SUBJECT: REQUEST FOR PROPOSALS FOR PERFORMANCE OF EXPERT PROFESSIONAL SERVICES FOR NEWARK LIBERTY INTERNATIONAL AIRPORT TERMINAL A REDEVELOPMENT PROGRAM – DESIGN OF TWO MULTIPLE-SPAN BRIDGE STRUCTURES (RFP #43730) - ADDENDUM #4

Figure 5 - Conceptual Bridge Section

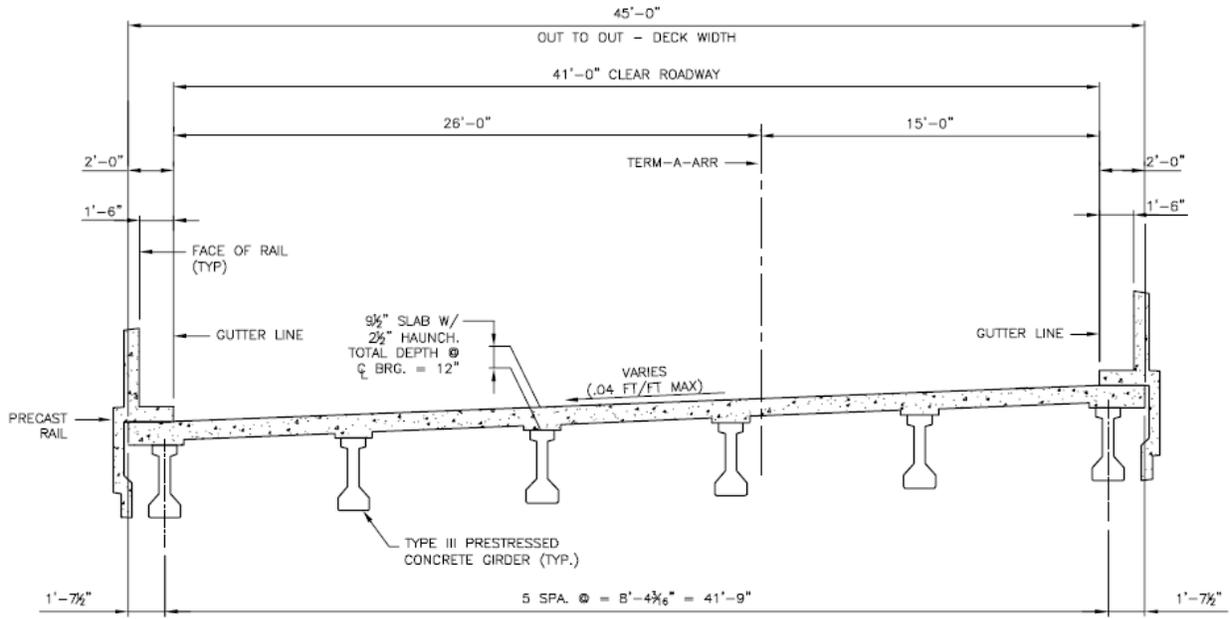
6. *Figure 5 depicts a concrete beam but indicates "steel plate girder". Which type of beam is correct?*

7. *Figure 5 depicts a concrete beam but indicates "steel plate girder". Which type of beam is correct?*

Response: "Steel Plate Girder (Typ.)" shown on Exhibit 1 - Figure 5 was a typographical error. See attached for an updated copy of Exhibit - Figure 5 in PDF.

Response: "Steel Plate Girder (Typ.)" shown on Exhibit 1 - Figure 5 was a typographical error. See attached for an updated copy of Exhibit - Figure 5 in PDF.
